# Technical BULLETIN

## 2006~2007 FJR1300A/AE

### Poor Engine Performance with Change in Altitude

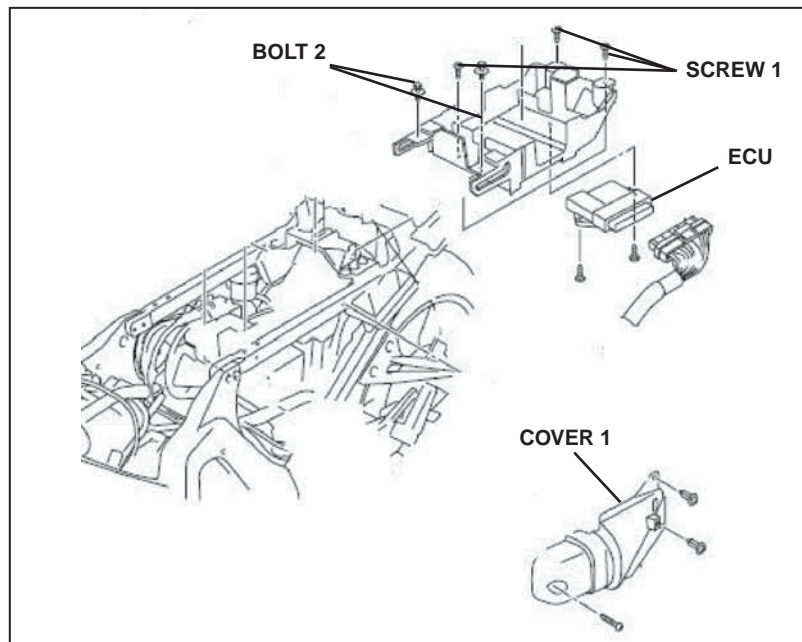
**Removal Tips:**

1. Remove left side cover.
2. Remove cover 1 and unplug ECU.
3. Disconnect and remove Shift ECU (AE models only).
4. Remove screw 1 (qty 3).
5. Remove bolt 2 (qty 2).
6. Lift and slide the front of the storage tray back past the rear fuel tank mount, then remove the storage tray.
7. Remove the ECU mounting screws and the ECU from the bottom of the storage tray.
8. Install the new ECU with mounting screws and reassemble in reverse order.
